# INDIANA RESIDENTIAL CODE

2001 EDITION

675 IAC 14-4.2

*Amended and effective on March 24, 2004*

**FIGURE R502.8  
CUTTING, NOTCHING AND DRILLING**

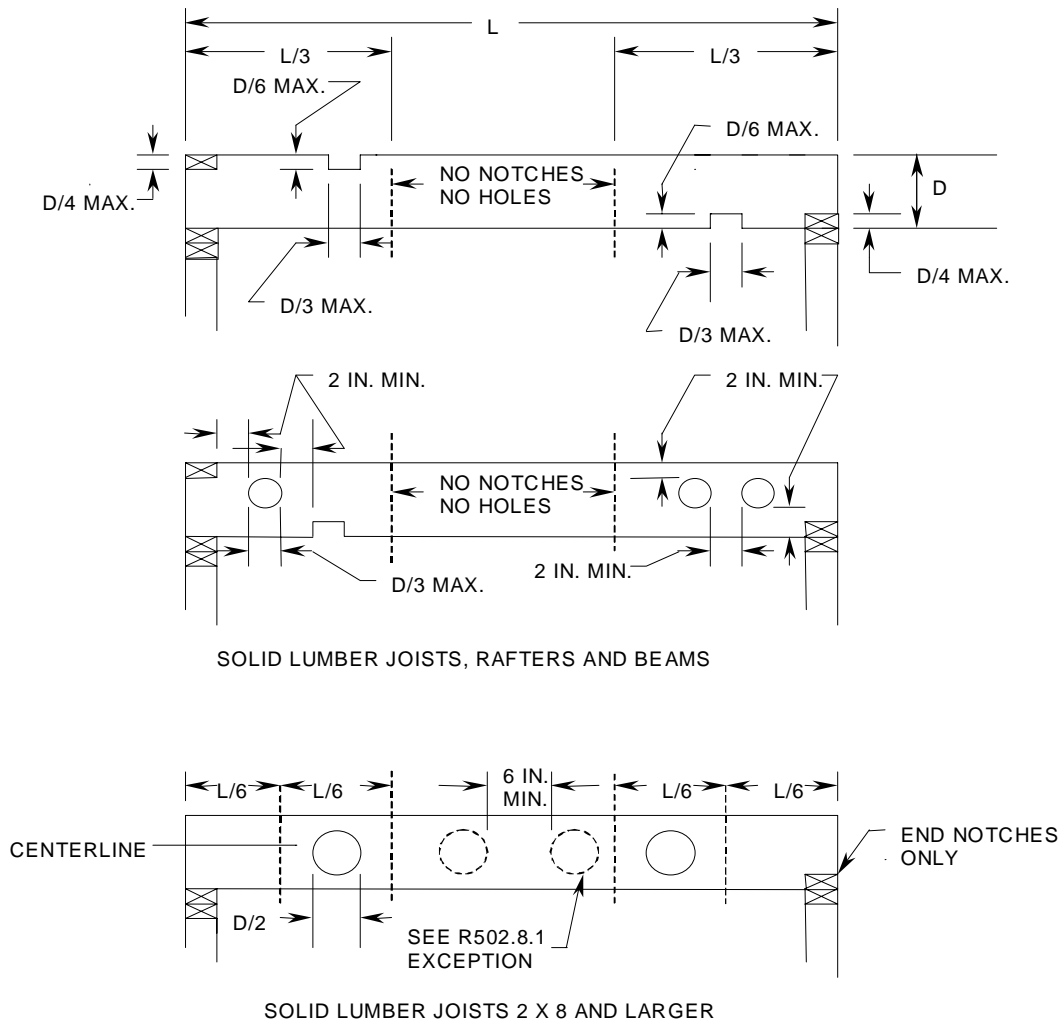
**Sec. 69.6. Delete FIGURE R502.8 and insert FIGURE R502.8 to read as follows:**

**FIGURE RR602.7.2**  
**TYPICAL WOOD STRUCTURAL PANEL BOX HEADER CONSTRUCTION**

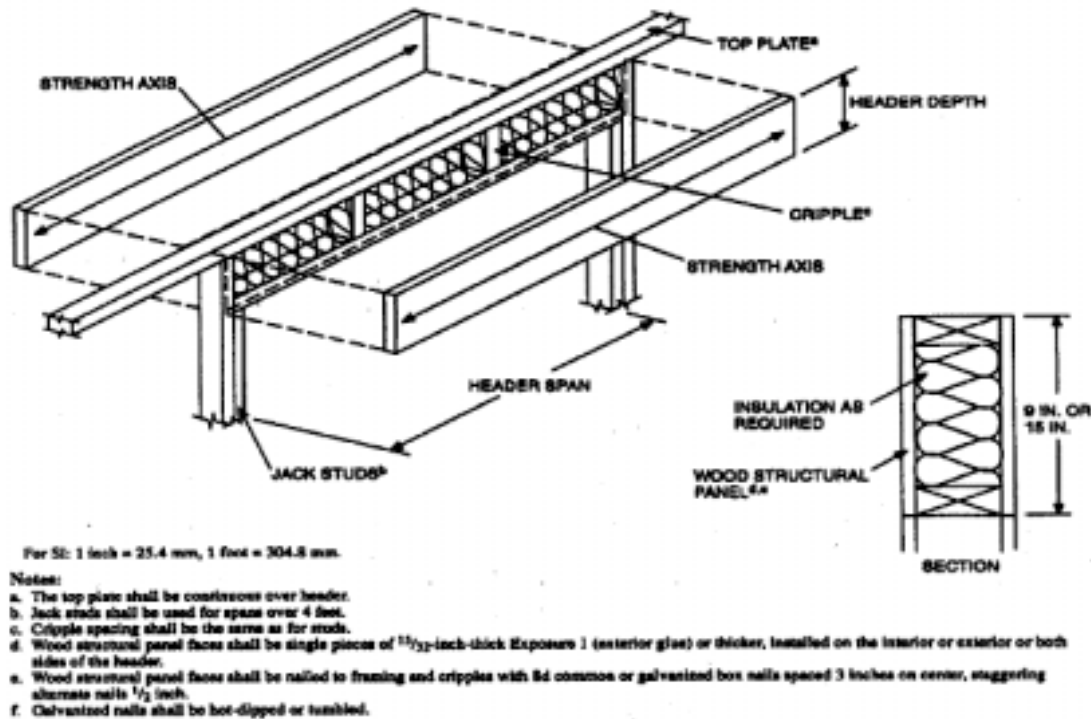
Sec. 77.5. Amend Figure R602.7.2 to read as follows:

**Figure R703.7; stone and masonry veneer, general**

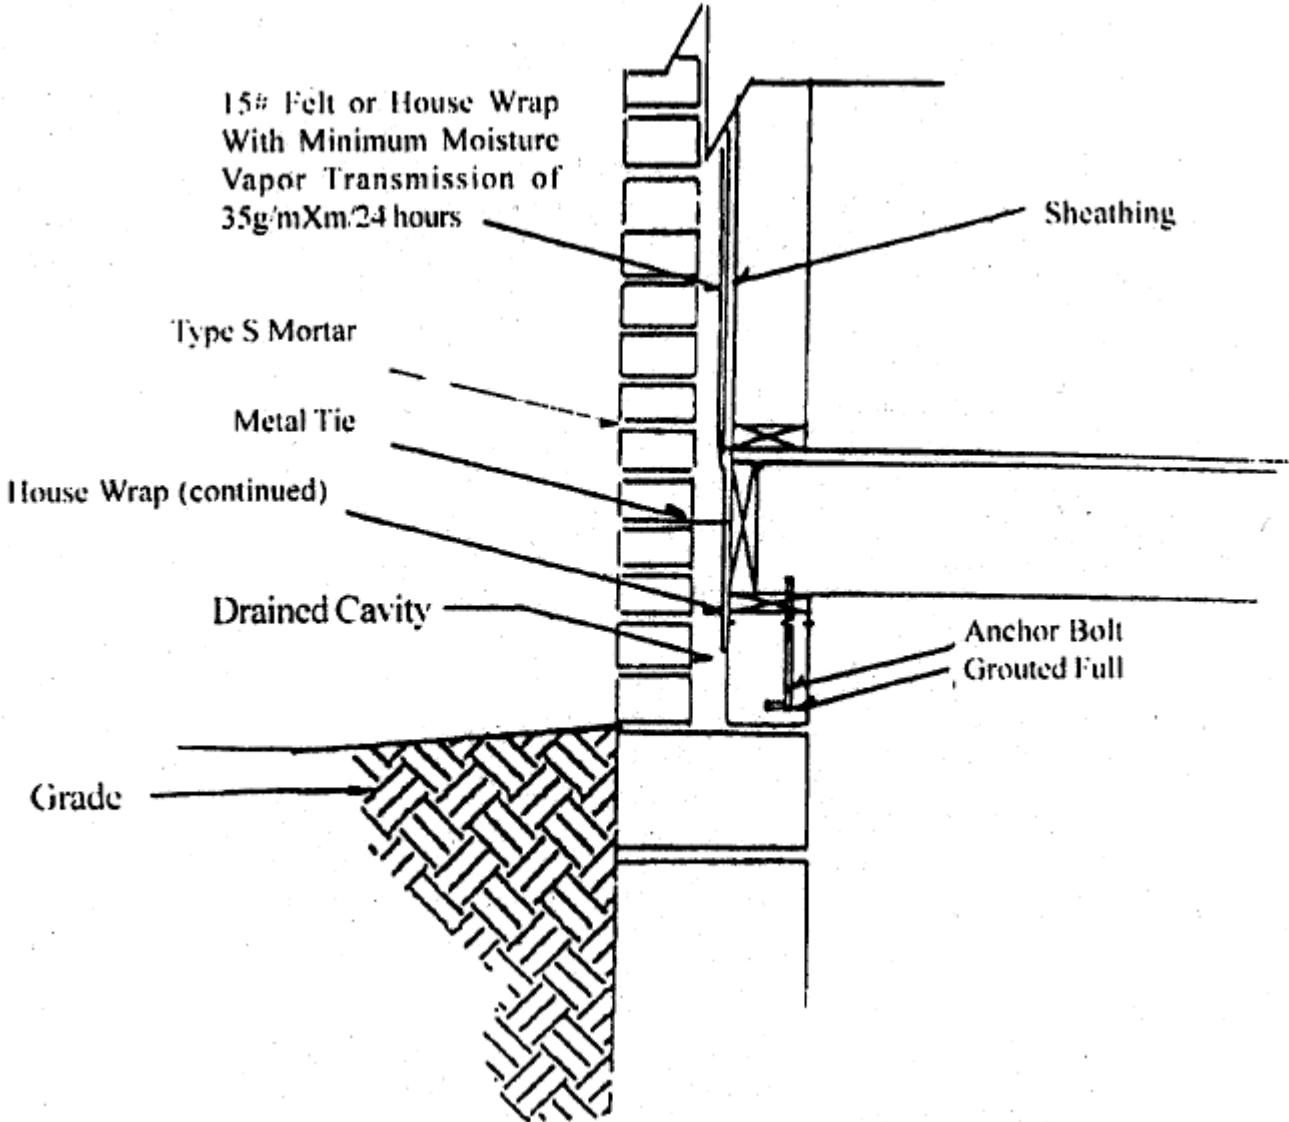
Sec. 89.6. Amend Figure R703.7 by modifying the flashing detail to show the horizontal flashing between the veneer and the top of the top course of the foundation wall and delete the horizontal flashing between the sill plate and the top course of the foundation wall. SECTION R703.7.4.3 by deleting "1 inch (25.4 mm)" and inserting "three-fourths (3/4)-

### Figure R1001.6; chimney termination

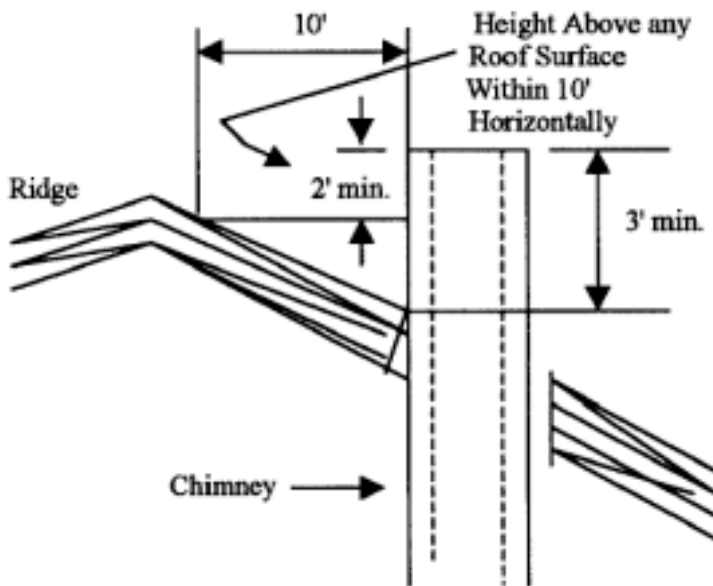
(b) Add a paragraph to the end of SECTION R1001.6 to read: See FIGURE R1001.6. (675 IAC 14-4.2-102) Eff June 22, 2001

Sec. 103. Add FIGURE R1001.6 as follows:  
FIGURE R1001.6
